Re: Preliminary Plat for Lavitt Manor II—Two Lot Subdivision: 7525 N. Ironwood Drive

Based solely on the current Town of Paradise Valley Code and Storm Drainage Design Manual, the revised documents provided to this Commission by the Applicant for the proposed Lavitt Manor II subdivision have deficiencies requiring the Preliminary Plat be rejected:

5. PUBLIC HEARINGS 19-302 CONSIDERATION OF PRELIMINARY PLAT

PAVING GRADING PLAN LAVITT MANOR II

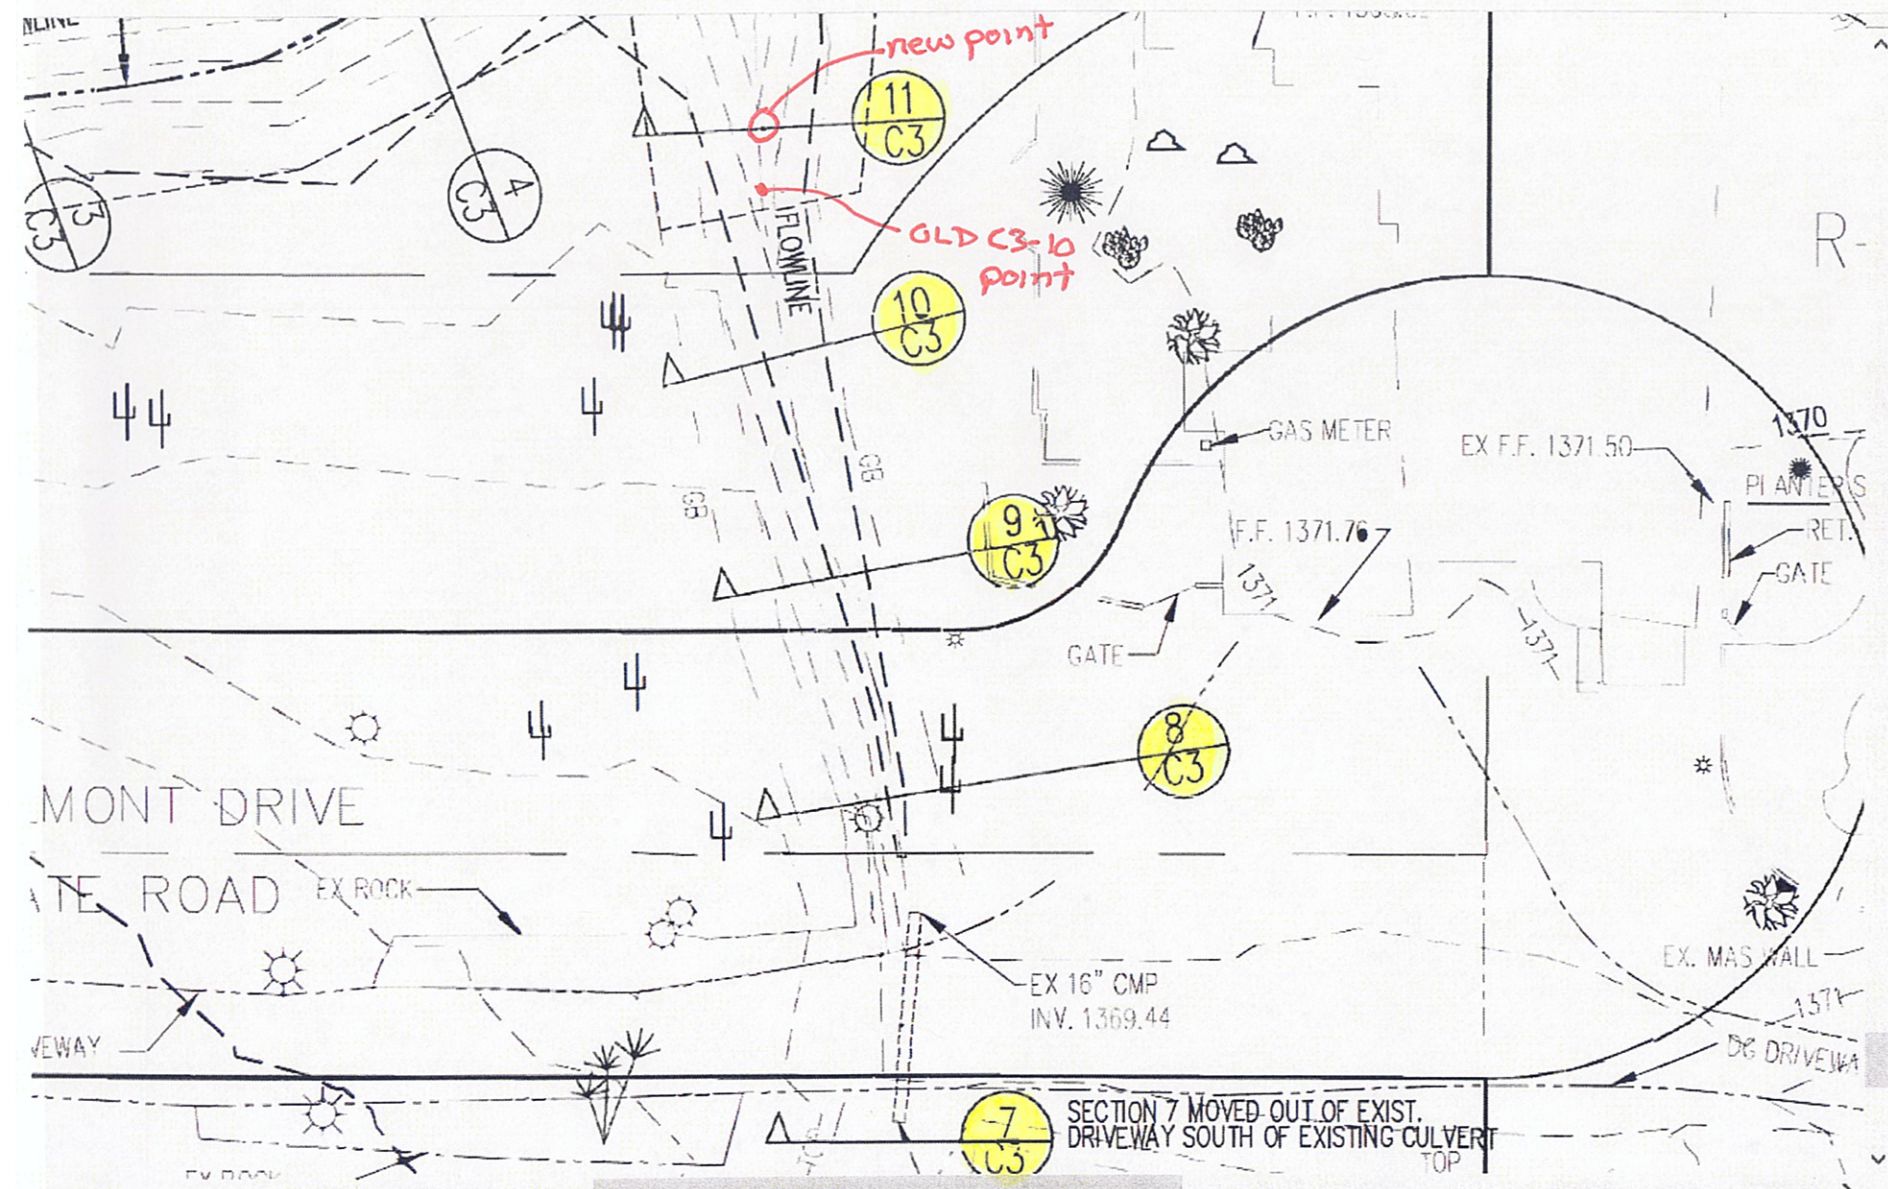
- Town of Paradise Valley is obtaining easement on Lot 1;
- Mandatory language (“shall”) to have a 5 foot landscape buffer on each side of wash;
- Current easement points approaches or encroaches Natural Wash at 3 points thus the landscape buffer is not appropriate;
- Plan should not be approved as it violates the Town Code.

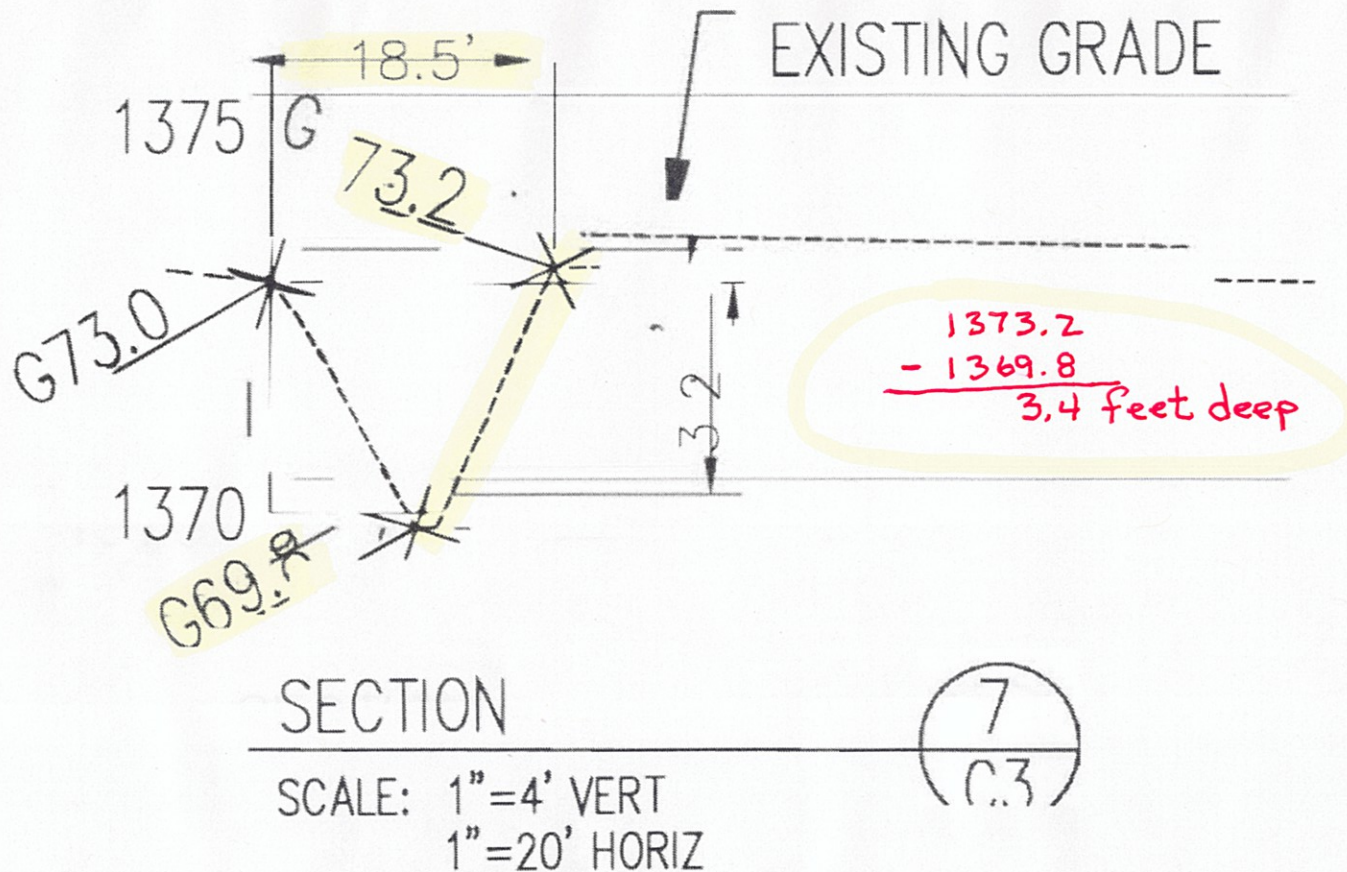
- Must consider both "historical banks" to determine depth;
- Nowhere does it say watercourse depth is taken from one bank, lowest bank, or existing grade of one bank.

- Width must be determined by taking a measurement at the "top of the bank";
 - Can only mean at the top of each bank, or one could not obtain a width measurement from one bank.
- Accordingly, to ensure the same "top of the bank" meaning throughout the provisions, "top of the bank" must mean top of each bank;
 - Depth measurements must be taken from the top of each historical bank of the wash.

- Width must be determined by taking a measurement "to the top of the bank";
 - Can only mean to the top of each bank, or one could not obtain a width measurement from one bank.
- Accordingly, to ensure the same "top of the bank" meaning throughout the provisions, "top of the bank" must mean top of each bank;
 - Depth measurements must be taken from the top of each historical bank of the wash to determine if it is a Natural Wash.

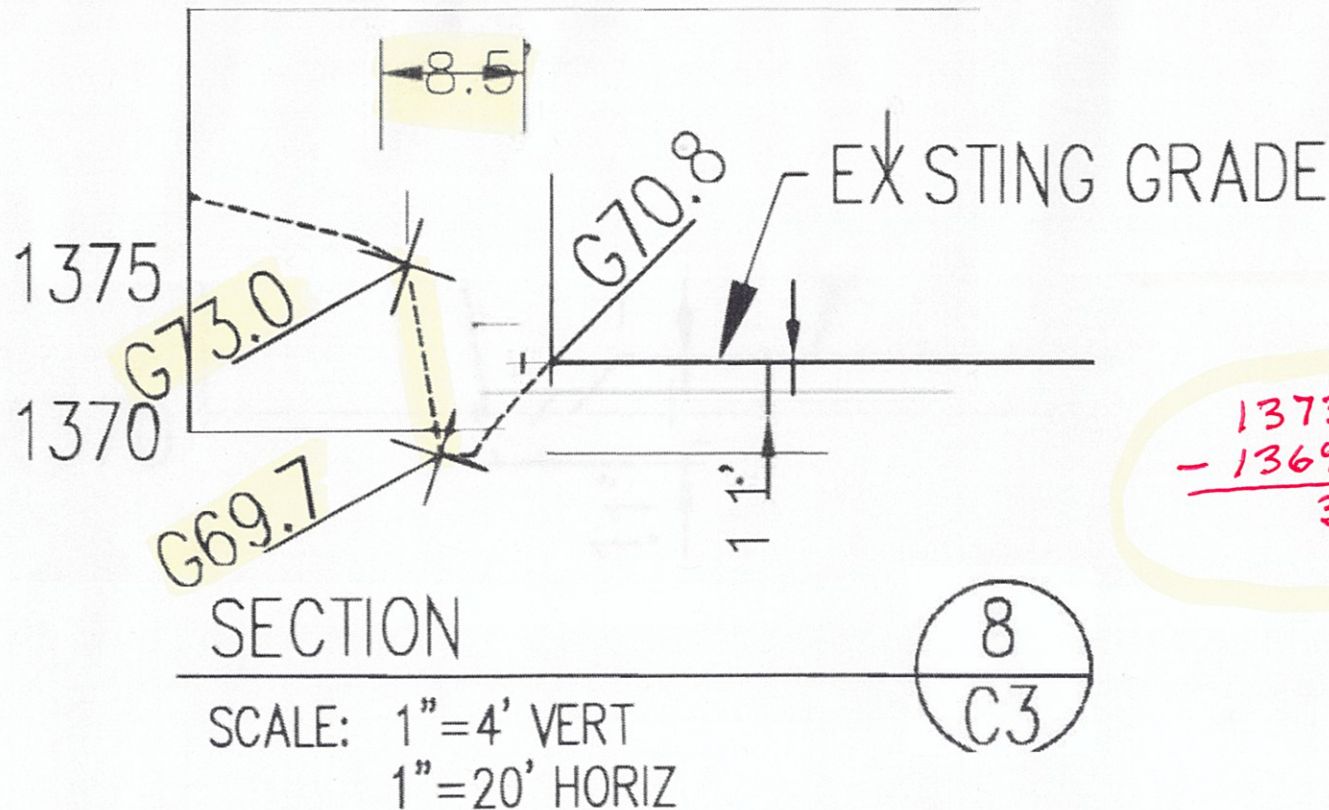
- Must consider both "historical banks" to determine depth;
- Nowhere does it say watercourse depth is taken from one bank, lowest bank, or existing grade of one bank.

- Width must be determined by taking a measurement at the "top of the bank";
 - Can only mean at the top of each bank, or one could not obtain a width measurement from one bank.
- Accordingly, to ensure the same "top of the bank" meaning throughout the provisions, "top of the bank" must mean top of each bank;
 - Depth measurements must be taken from the top of each historical bank of the wash.

- Width must be determined by taking a measurement "to the top of the bank";
 - Can only mean to the top of each bank, or one could not obtain a width measurement from one bank.
- Accordingly, to ensure the same "top of the bank" meaning throughout the provisions, "top of the bank" must mean top of each bank;
 - Depth measurements must be taken from the top of each historical bank of the wash to determine if it is a Natural Wash.

$$\begin{array}{r} 1373.0 \\ - 1369.7 \\ \hline 3.3 \text{ feet deep} \end{array}$$

SECTION

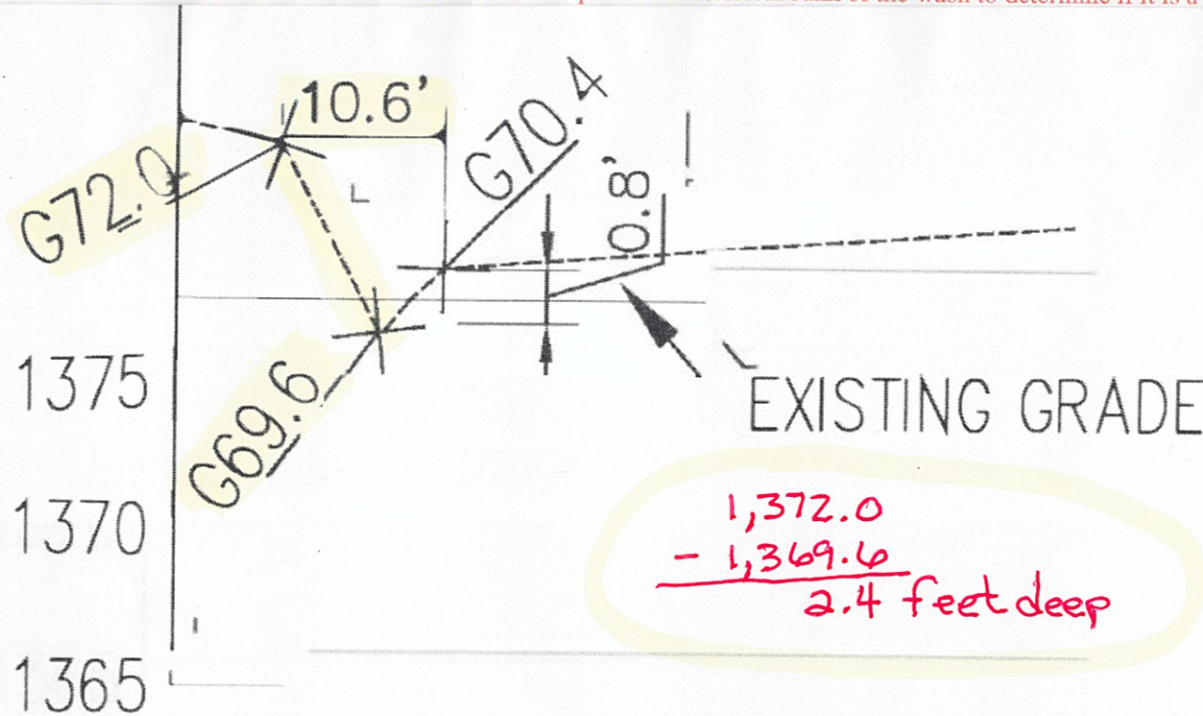
- Must consider both "historical banks" to determine depth;
- Nowhere does it say watercourse depth is taken from one bank, lowest bank, or existing grade of one bank.

- Width must be determined by taking a measurement at the "top of the bank";
 - Can only mean at the top of each bank, or one could not obtain a width measurement from one bank.
- Accordingly, to ensure the same "top of the bank" meaning throughout the provisions, "top of the bank" must mean top of each bank;
 - Depth measurements must be taken from the top of each historical bank of the wash.

- Width must be determined by taking a measurement "to the top of the bank";
 - Can only mean to the top of each bank, or one could not obtain a width measurement from one bank.
- Accordingly, to ensure the same "top of the bank" meaning throughout the provisions, "top of the bank" must mean top of each bank;
 - Depth measurements must be taken from the top of each historical bank of the wash to determine if it is a Natural Wash.

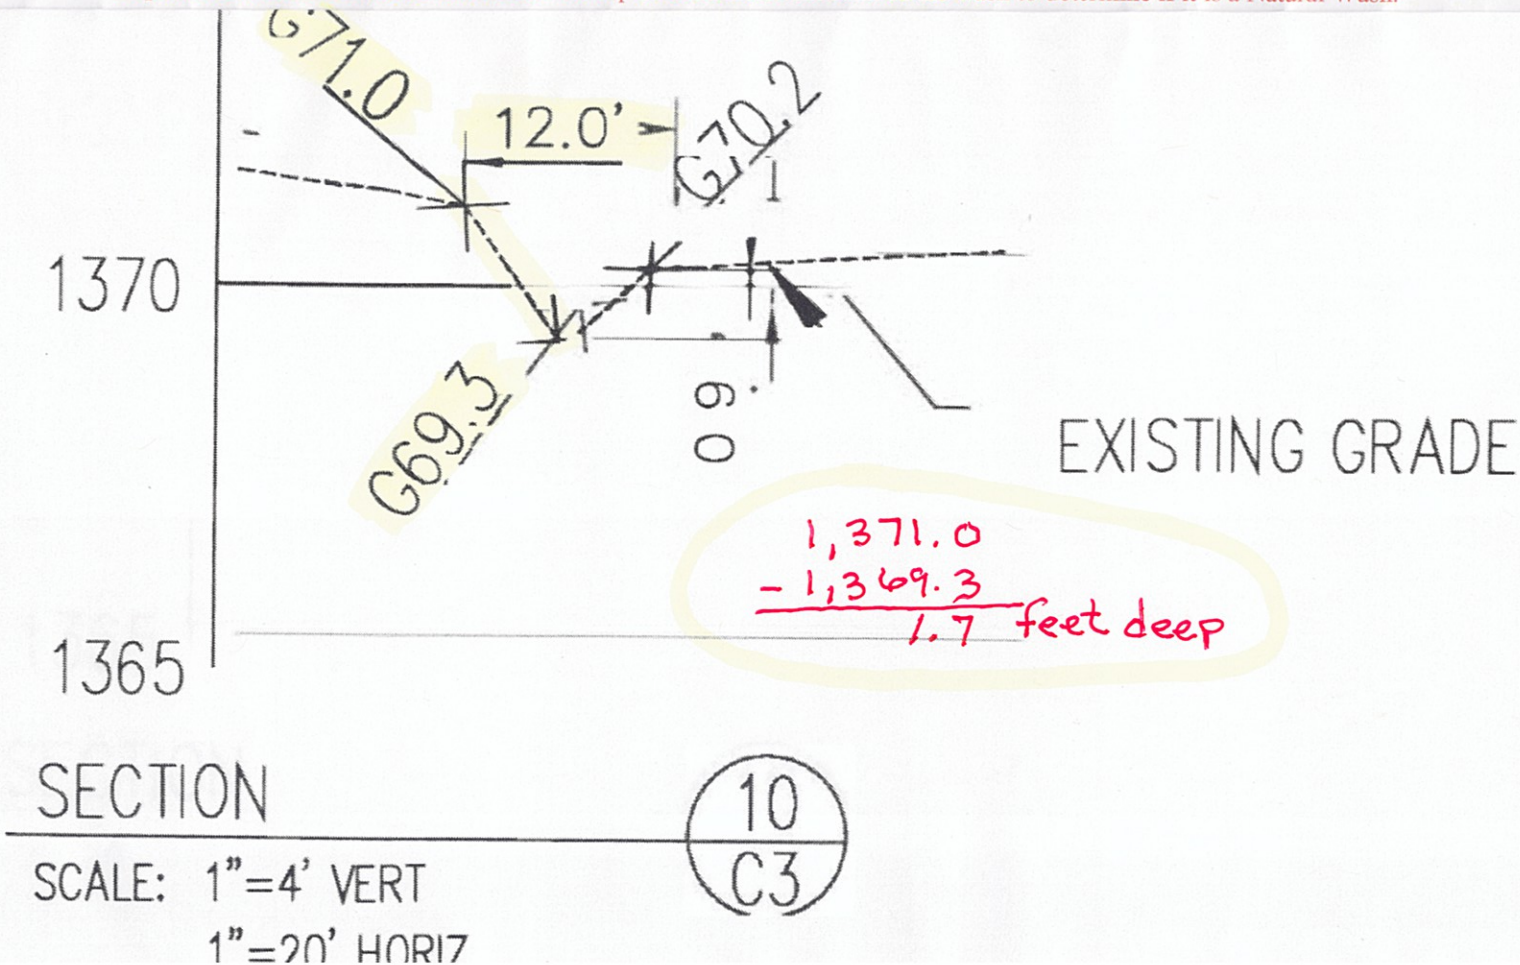
- Must consider both "historical banks" to determine depth;
- Nowhere does it say watercourse depth is taken from one bank, lowest bank, or existing grade of one bank.

- Width must be determined by taking a measurement at the "top of the bank";
 - Can only mean at the top of each bank, or one could not obtain a width measurement from one bank.
- Accordingly, to ensure the same "top of the bank" meaning throughout the provisions, "top of the bank" must mean top of each bank;
 - Depth measurements must be taken from the top of each historical bank of the wash.

- Width must be determined by taking a measurement "to the top of the bank";
 - Can only mean to the top of each bank, or one could not obtain a width measurement from one bank.
- Accordingly, to ensure the same "top of the bank" meaning throughout the provisions, "top of the bank" must mean top of each bank;
 - Depth measurements must be taken from the top of each historical bank of the wash to determine if it is a Natural Wash.

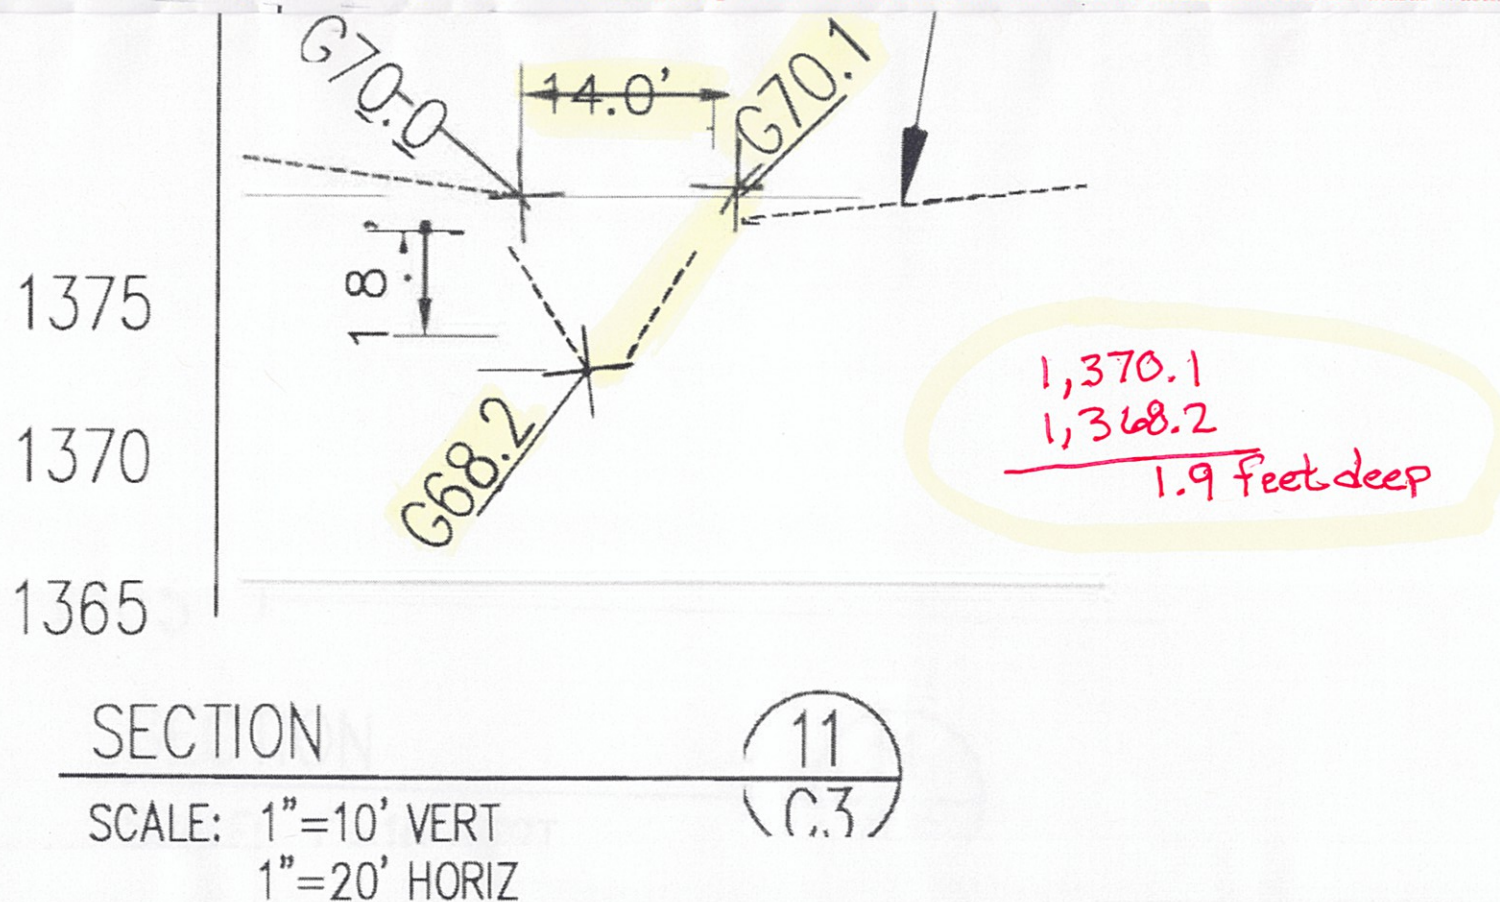
- Must consider both "historical banks" to determine depth;
- Nowhere does it say watercourse depth is taken from one bank, lowest bank, or existing grade of one bank.

- Width must be determined by taking a measurement at the "top of the bank";
 - Can only mean at the top of each bank, or one could not obtain a width measurement from one bank.
- Accordingly, to ensure the same "top of the bank" meaning throughout the provisions, "top of the bank" must mean top of each bank;
 - Depth measurements must be taken from the top of each historical bank of the wash.

- Width must be determined by taking a measurement "to the top of the bank";
 - Can only mean to the top of each bank, or one could not obtain a width measurement from one bank.
- Accordingly, to ensure the same "top of the bank" meaning throughout the provisions, "top of the bank" must mean top of each bank;
 - Depth measurements must be taken from the top of each historical bank of the wash to determine if it is a Natural Wash.

PAVING GRADING DRAINAGE LAVITT MANOR II

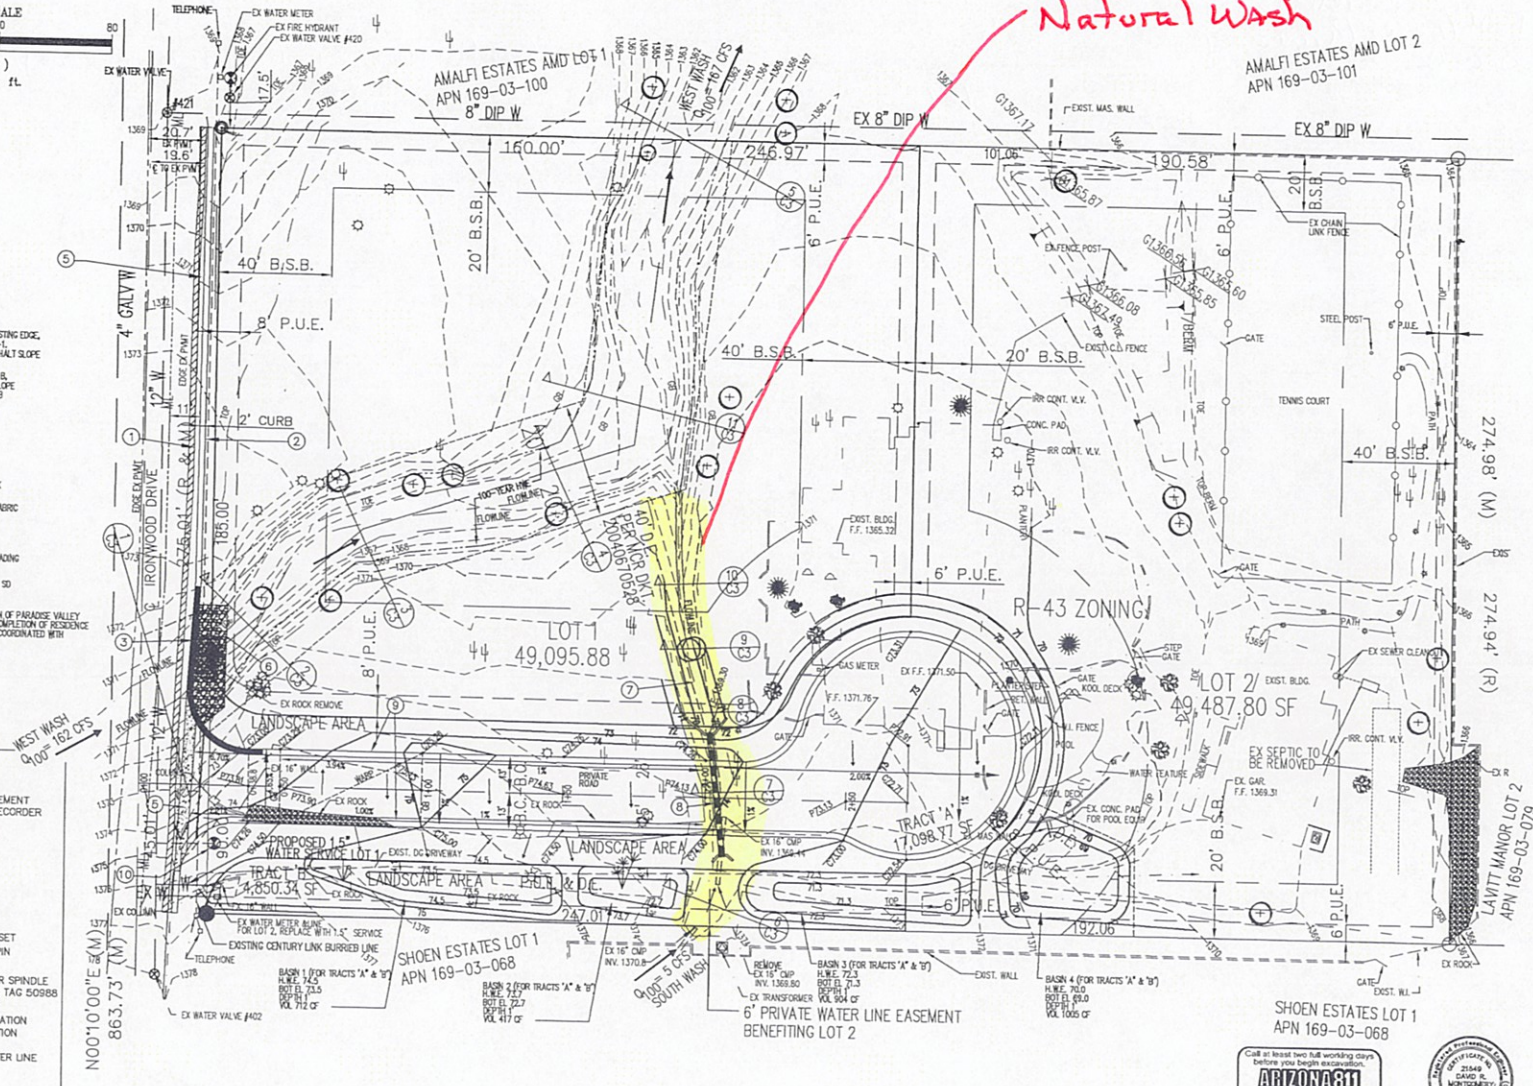
Suspected
Natural Wash

Did NOT provide LANDSCAPE BUFFER OR
EQUALLY SPACED CROSS SECTION ACROSS ENTIRE WASH

DRAINAGE 3-6(2)
DRAINAGE 3-6(3)
PV CODE 5-10-7
PV CODE 6-3-8
